Construction Division
Additions & Alteration Charges Approval Form

GULMOHAR RESIDENCY

Details of Additions & Alterations

Flat No	306	Block no.	' C '
Flat Area	1660 sft	Type	Deluxe / Luxury
Buyer Name	Mr. A Praveen		
Phone No.	8106673078	Email

Description	Direction	Owners & Developers :	Date :	Promoted by
WORKING PLAN-1660 Sft-B1 TYPE	N 	Modi Reality Mallapur LLP Project Name & Phase :	25 09 2020 Prepared By : Jayapradha Approved By : Soham Modi	Modi Properties Pvt Ltd

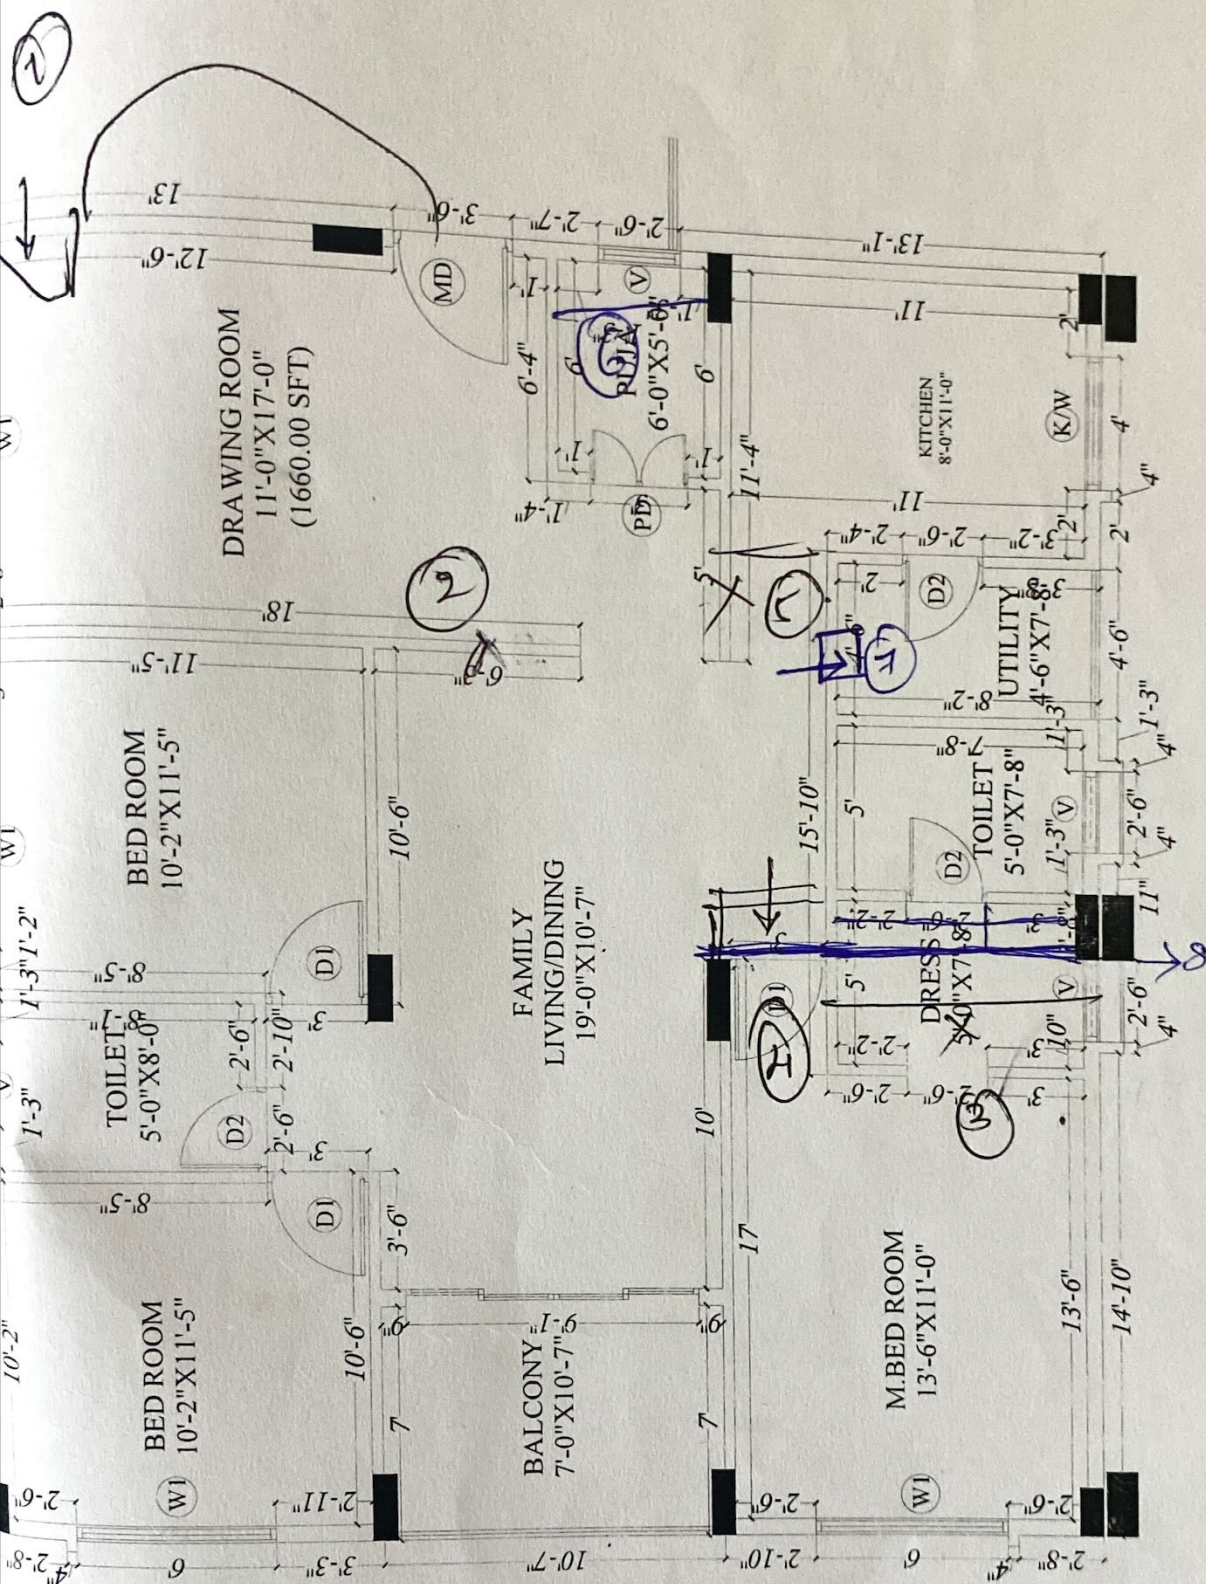
① - Electrical changes as per plan.

- ① main Door shift
- ② Partition removal
- ③ Dress room removal
- ④ MBD door to be moved
- ⑤ Kitchen Extension to be removed
- ⑥ In pooja need granite upto height of 16" from FFL
- ⑦ Utility door to shifted & make 3'0" entrance.
- ⑧ Toilet to be ~~column~~ aligned. Toilet to big.
